Service Bulletin

No. : MZ08-025_2nd

Model: SA-7S1, SA-11S2

Subject: Irregular operation improvement by static electricity

1) LEAF SPRING

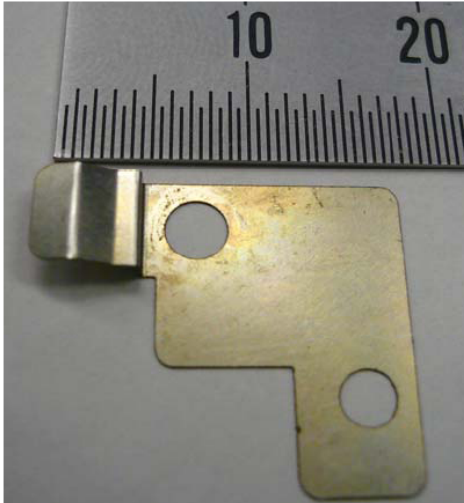
Solution: The TRAY SHAFT and the CHASSIS will be contacted with a LEAF SPRING in between so that the tray will be grounded.

- 1) One LEAF SPRING added
- 2) SHAFT-GUIDE-R (POS. NO. 16) to be replaced (The depth of the recess the LEAF SPRING is installed in has been changed to 0.1mm.)

2) SHAFT-GUIDE-R (POS. NO. 16)

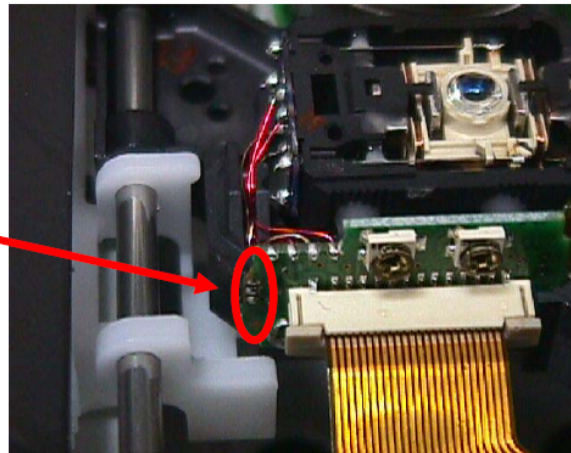
Old Part no. 00M27AK051320

New

The depth of the recess on this surface has been changed to 0.1mm.

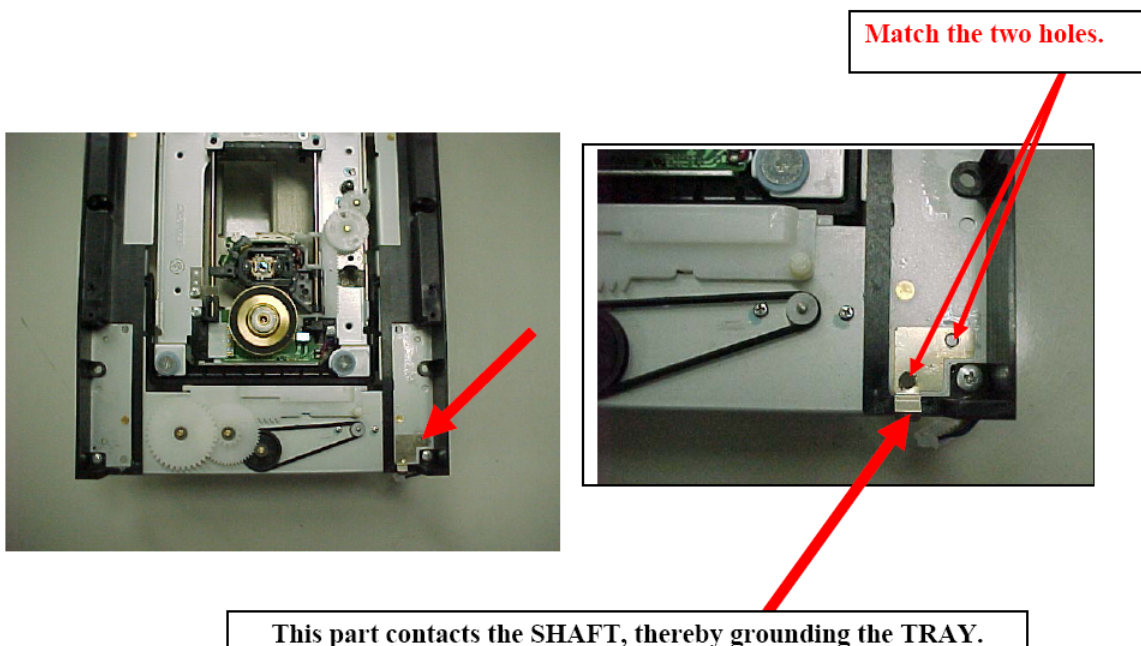
9. Place the LEAF SPRING in the position shown in the picture below. Match the two holes of the chassis and those of the LEAF SPRING.
